February 3, 2025

PROJECT NAME: FIRESTONE OCALA FREEDOM

PROJECT NUMBER: 2024090064

APPLICATION: MAJOR SITE PLAN #32039

DATE **01/31/2025** SHEET **C1**

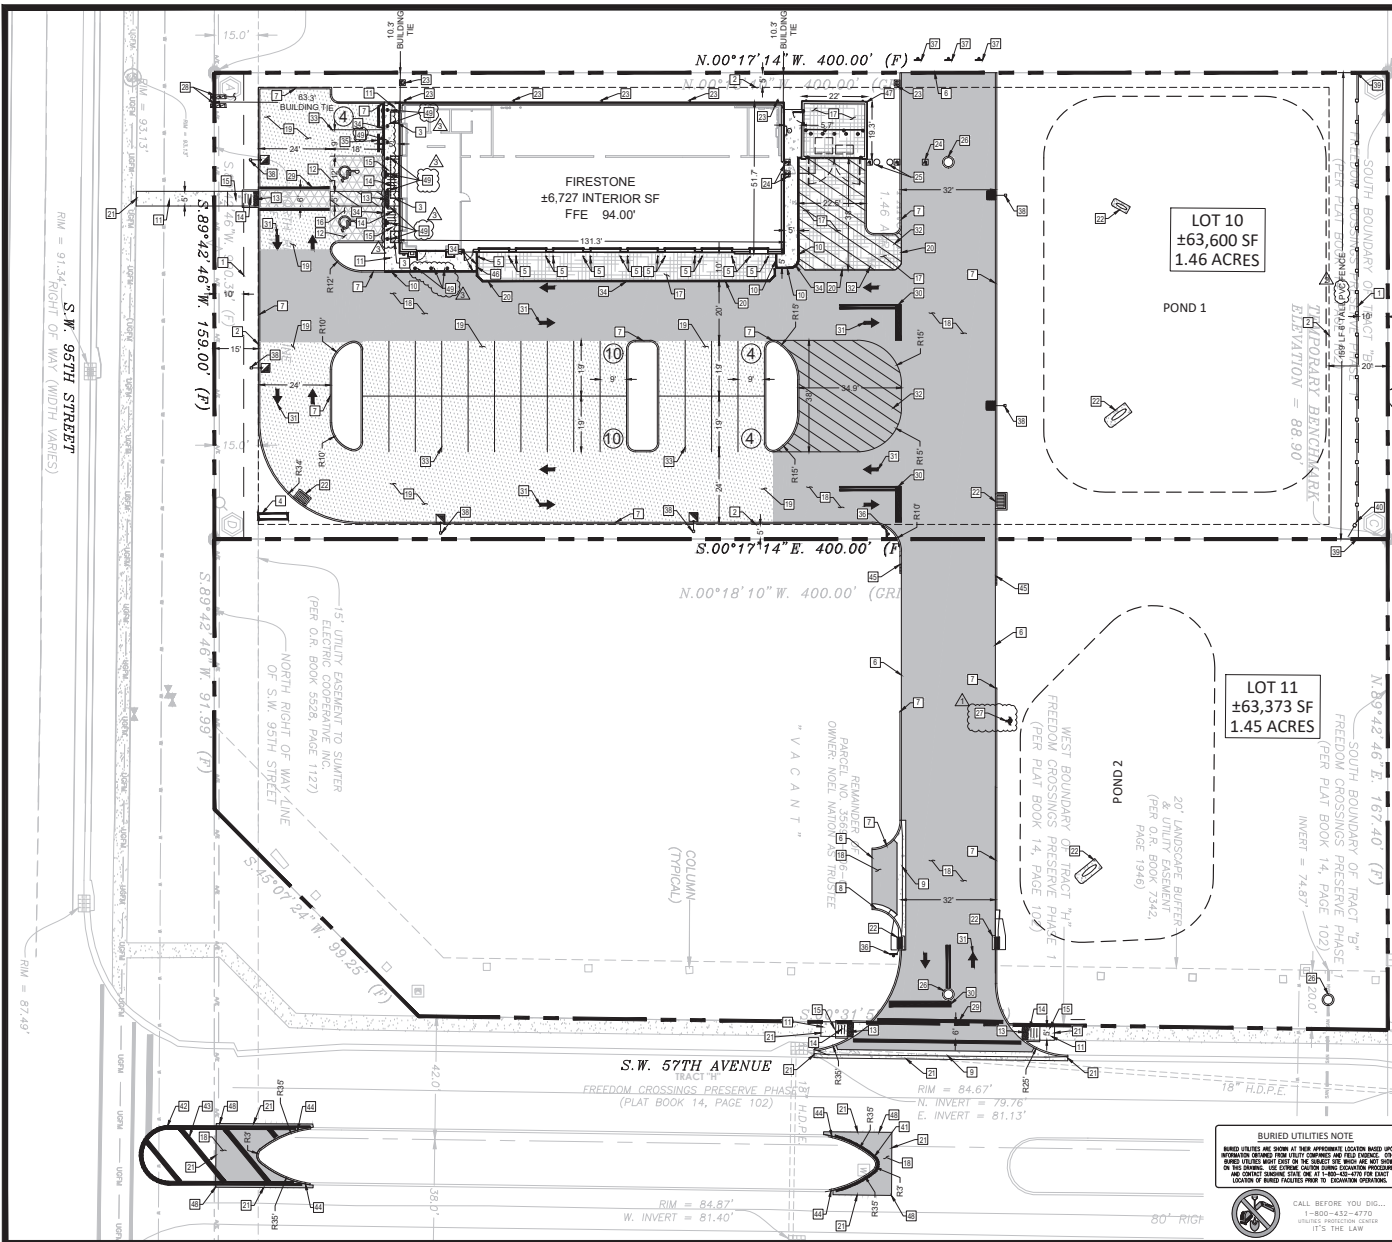
1/6/25- there are no adjacent properties on the plans showing the zoning and/or land use classifications. As stated on your comment response letter that it is on rev.1, sheet C1, however, it is not on the cover page, or overall C1 site plan, or C1.1.

PROJECT # **224.059**
DATE **01/31/2025**
SCALE **1" = 20'**
SHEET **C5**
UTILITY PLAN

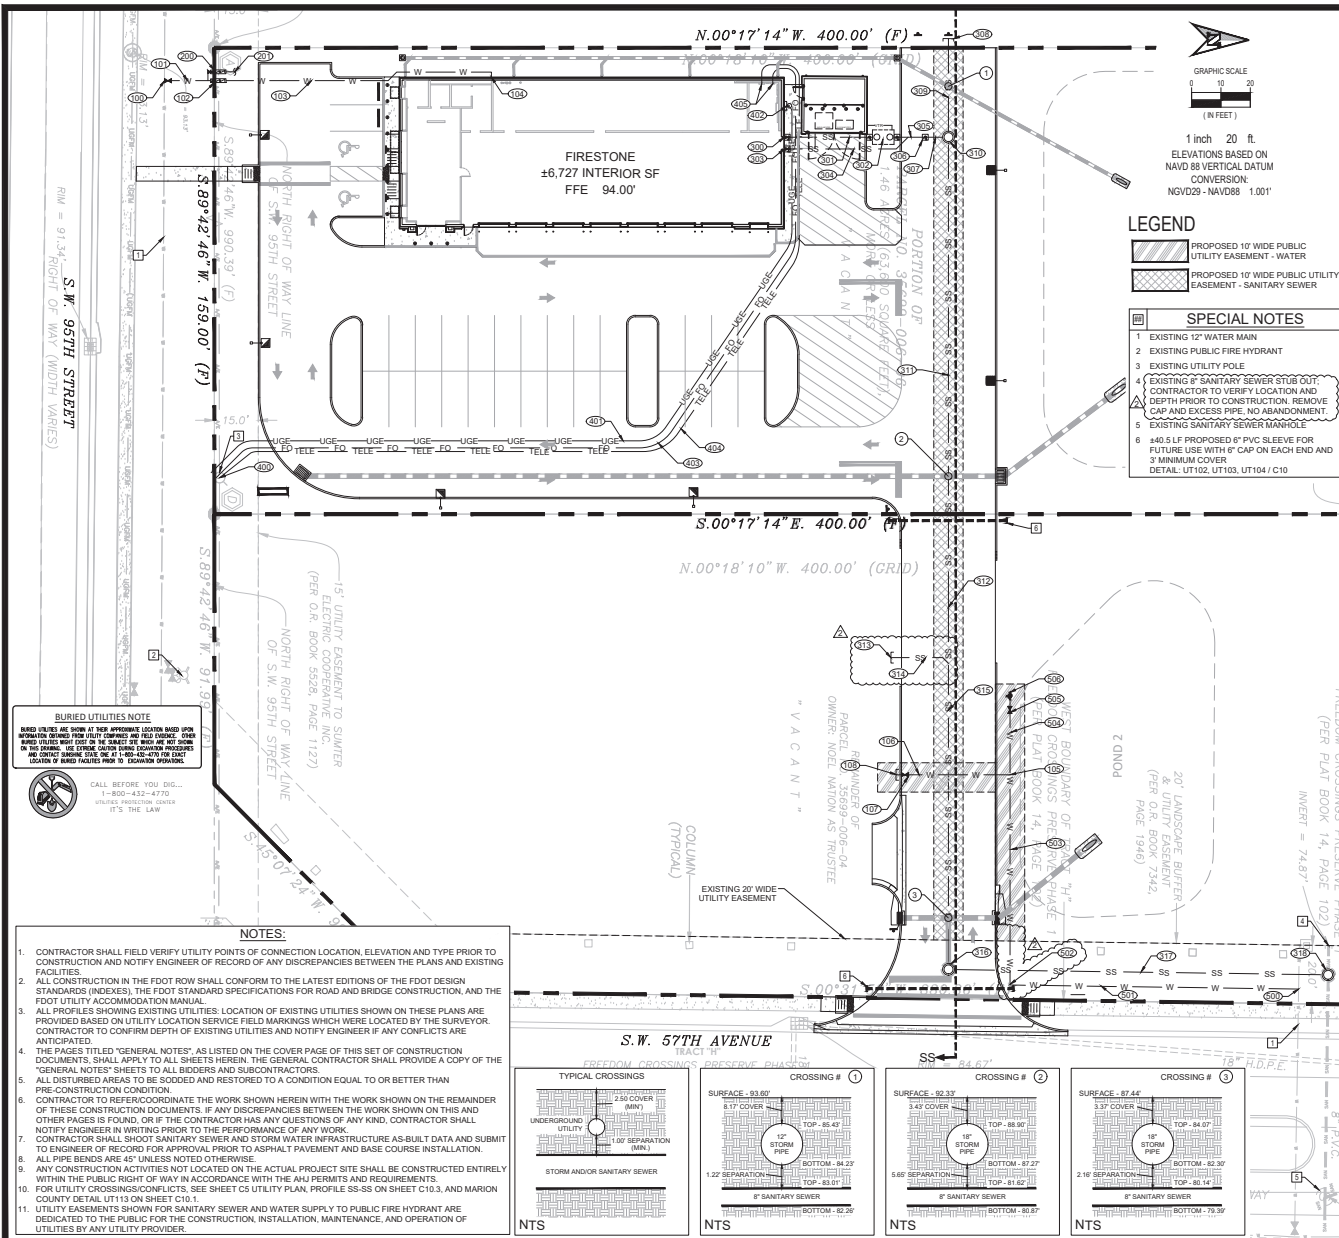
- 29 DEPARTMENT: UTIL - MARION COUNTY UTILITIES
REVIEW ITEM: 6.15.1 - Potable Water Distribution System
STATUS OF REVIEW: NO
REMARKS: Utility Plan Keynotes: 1. Water connection Note 100 - connect with gate valve; do not use 2" curb stop for taps 2. Irrigation Note 200 - reducer needs to be OUTSIDE of the meter box 3. proposed connection for hydrant will make parallel mains on SW 57th Ave; avoid if possible 4. tap must be done with sleeve; saddle will not be acceptable 5. bring main down to a restrained 90 instead of using 2x22.5* fittings (see ePlans for sketch) 6. No reducers shall be inside meter box or on county side of property line 7. what is the proposed depth of the line to the hydrant considering it will be 'trapped' between a road and a pond?

- 30 DEPARTMENT: UTIL - MARION COUNTY UTILITIES
REVIEW ITEM: 6.16.4 - Wastewater Collection Systems (Gravity/Pressurized) Design
STATUS OF REVIEW: NO
REMARKS: Utility Plan Keynotes: 1. Structure 318 needs to be a standard manhole; eliminate cap at the end of the sanitary sewer. 2. Sewer note 310 & 318 - all drop manholes to be lined and have composite ring and cover (update note) 3. Sewer note #314 - move this to a property corner & from outside the middle of a driveway (or just outside the paved area if corner is not feasible)

3 750 GALLON OIL/WATER SEPARATOR NTS

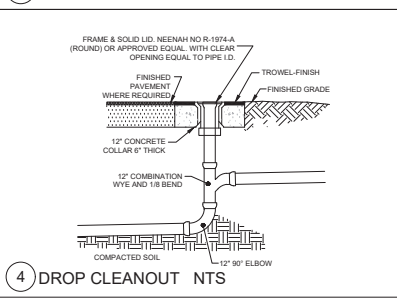
- 28 DEPARTMENT: UTIL - MARION COUNTY UTILITIES
REVIEW ITEM: 6.14.2.C - Industrial Pretreatment
STATUS OF REVIEW: NO
REMARKS: 1/6/25 addendum to original comment: Add OWS calculations to Utility Details close to the OWS detail on Sheet C10.2; they will need to be signed & sealed as compliant with the rest of the plan set.
ORIGINAL COMMENT: see notes on Sheet C10.2 & C5 RE: oil water separator
